TECHNICAL BULLETIN

212-11-212  
6 April 2011

**SUBJECT:** GENERATOR GROUNDING, IMPROVEMENT OF.

**HELICOPTERS AFFECTED:** Model 212 helicopters serial number 30501 through 30999, 31101 through 31311, 32101 through 32142 and 35001 through 35103.

**Figure 1**  
LH Ground Tab Installation  
(RH side typical)

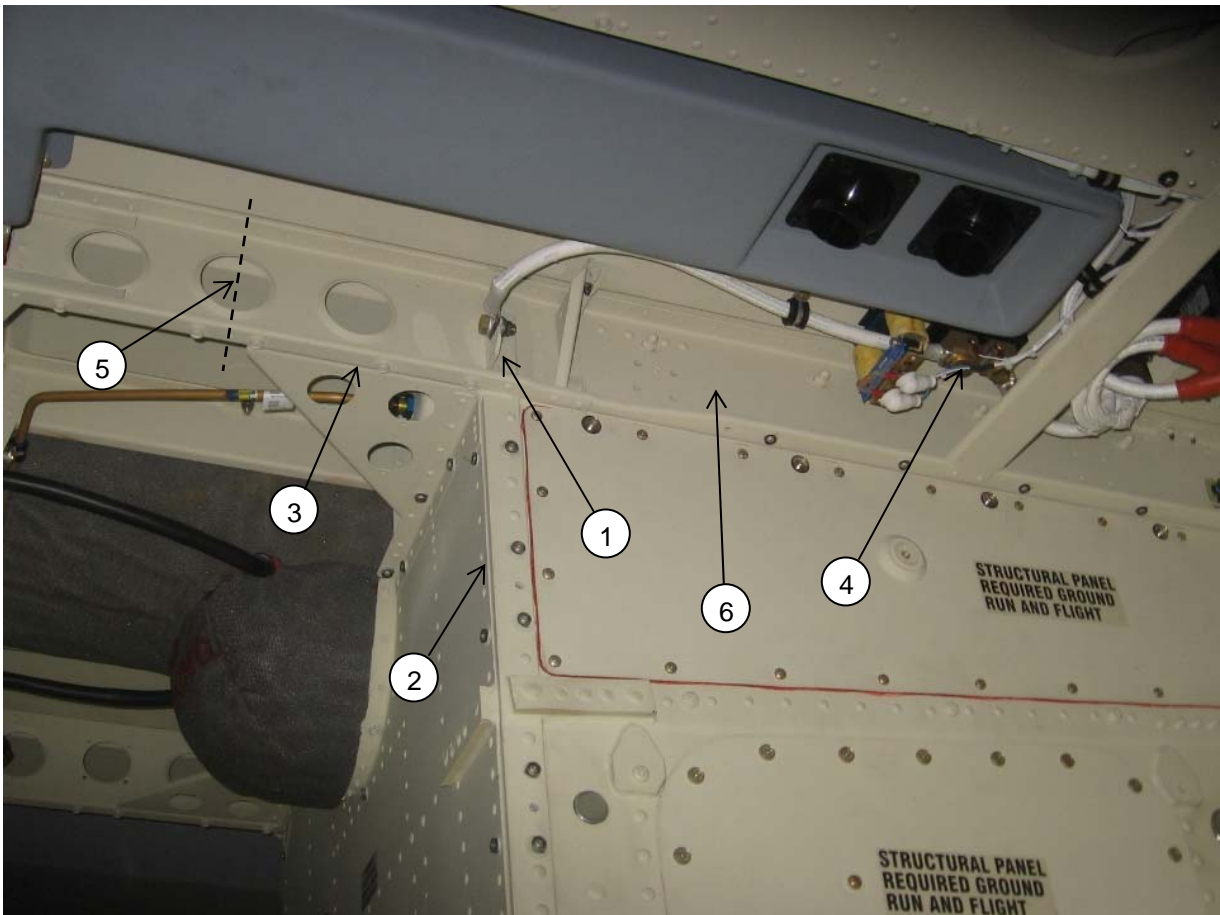
3. Locate the two generator ground tabs P/N 212-030-042-003 located on roof section at FS 129 (1, Figure 1).
4. Disconnect ground cable from both ground tabs. Retain attaching hardware.

5. Using paint remover (C-436), remove finish from a suitable area on both ground tabs and corner angles.
6. Using a suitable milliohm meter measure the resistance across each generator ground tab (1) and the corresponding Angle (2) as described in the Electrical Standard Practices Manual (BHT-ELEC-SPM).

7. If resistance is greater than 0.25 milliohms, perform the following modification. If resistance is less than 0.25 milliohms, go to step 9.
  - a. Remove ground tab (1) by drilling out attaching rivets.

- b. Using paint remover (C-436), remove any paint on contact area of grounding tab (1) and Frame (3). Inspect contact area for corrosion. Remove corrosion as required, as per BHT-ALL-SRM Chapter 3.

- d. Re-install grounding tab using 100-048-5-6 Pins (heads outboard) and 30-015-5 Collars. Refer to BHT-ALL-SRM, Chapter 3 for the procedure.
  - e. Verify if resistance is less than 0.25 milliohms. If so, go to step 9.

8. If resistance is still greater than 0.25 milliohms, perform the following modification.
- a. Remove ground tab (1).
  - b. Cut Frame (3) at approx. FS 119.31, as shown in Structural Repair Manual, paragraph 4-6-11. Limit the width of the cut to a minimum to allow acceptable edge distance on existing rivets as the same aft section of frame will be reused (unless damaged). Take note of type and location of rivets.

- c. Remove remaining rivets to allow removal of the aft section of frame (3).
  - d. Using paint remover (C-436), remove any paint on contact area of Angle (2), Web (6) and back side of Frame (3). Inspect contact area for corrosion. Remove corrosion as required, as per SRM Chapter 3.

- e. Prepare bonding surface as described in ESPM, Chapter 8.
  - f. Re-install aft section of frame using paragraph. 4-6-11 of the BHT-MED-SRM.
  - g. Re-install grounding tab using new pins and collars.

- h. Confirm resistance is less than 0.25 milliohms.
9. Connect ground cables using retained hardware.
10. Verify for continuity between the generator shunt (4) and local ground.

11. Apply sealant (C-392) to seal edges of ground cable lug, grounding tab (1), angle (2) and frame (3) to prevent moisture ingress.
12. Refinish all bare metal surfaces using Chemical Film (C-100) and primer (C-204).
